Work Order ID 90955

Item Name: Crosstube Turning Detail

DART AEROSPACE LTD	Work Order: 90951
Description: Crosstube Assembly (205/212 High Aft)	Part Number: D212-664-241
Inspection Dwg: D212-664-241 Rev: D	Page 1 of 2

DRAWING NO. D212-664-241	TITLE CROSSTUBE ASSY (205/212 HI AFT)	REV. D	DART AEROSPACE LTD ENGINEERING ORDER		D.E.O. NO. D212-664-241-D-1	SHEET NO. SHEET 1 OF 2	SCALE NTS
DRAWN	CHECKED	MFG. APPR.	APPROVED	DE APPR.			
DATE 11.04.07	DATE 11.04.11	DATE 11.04.12	DATE 11/04/12	DATE 11.04.12

**D212-664-241/-241B
ASSEMBLY DETAIL**

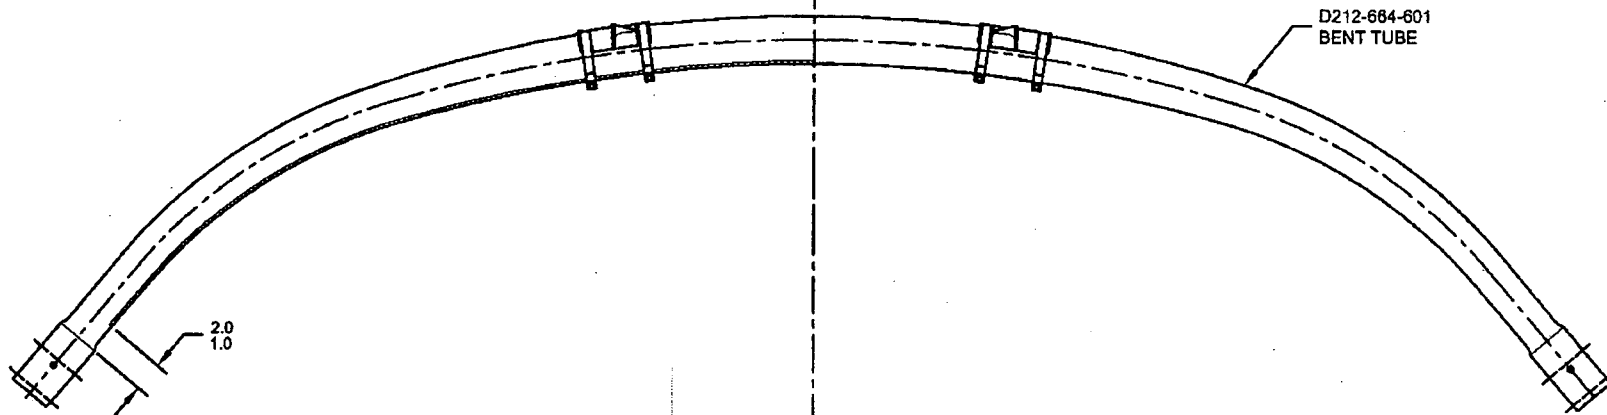
PURPOSE:

ADD AN INSPECTION WINDOW TO UNDERSIDE OF CROSSTUBE.

MASK AREA PRIOR TO PAINTING,
REMOVE MASKING AFTER PAINT
AND APPLY CLEAR COAT

- 2) FINISH: CHEMICAL CONVERSION COAT PER DART QSI 005 4.1
PRIME INSIDE AND OUTSIDE PER DART QSI 005 4.2
MASK UNDERSIDE OF CROSSTUBE AS SHOWN (HATCHED AREA) AND
PAINT OUTSIDE PER DART QSI 005 4.2
REMOVE MASKING AND APPLY CLEAR COAT
